Reply

Orientation Control System: Enhancing Aerial Maneuvers for Quadruped Robots

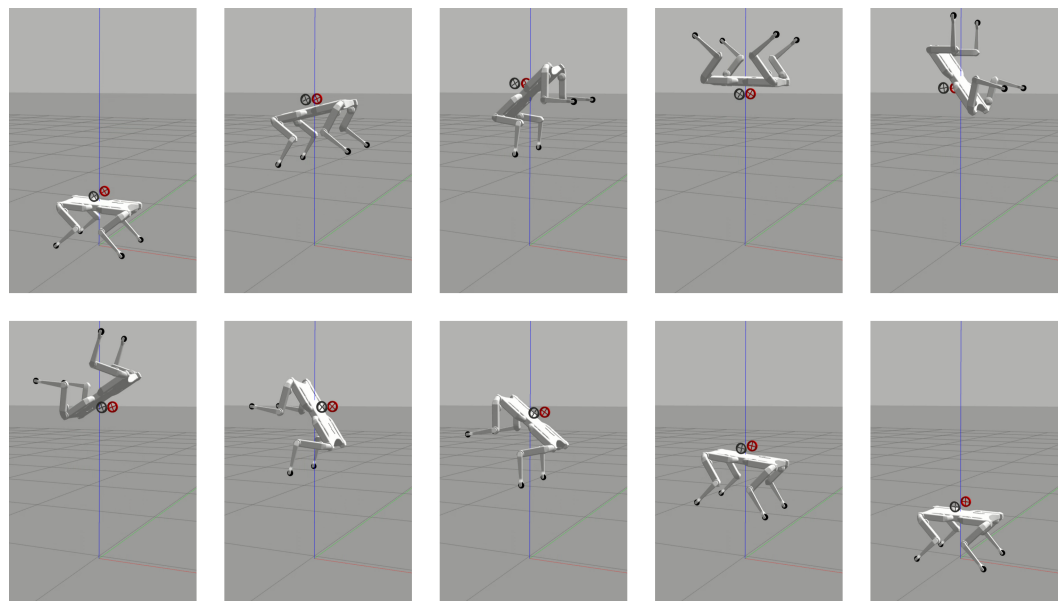
- **Comment 1:** *'All the simulations are performed in Gazebo'. The paper must have more details related with the simulation, including a snapshot of the simulated robot in its environment.*

Response: Thank you for the insightful comment. We summarized the details of the simulation in Table 1, which is incorporated to the manuscript too. Moreover, inspired by your suggestion, we attached a sequence of snapshots for the third simulation (back-flip), showing the robot in the Gazebo environment (Fig. 1).
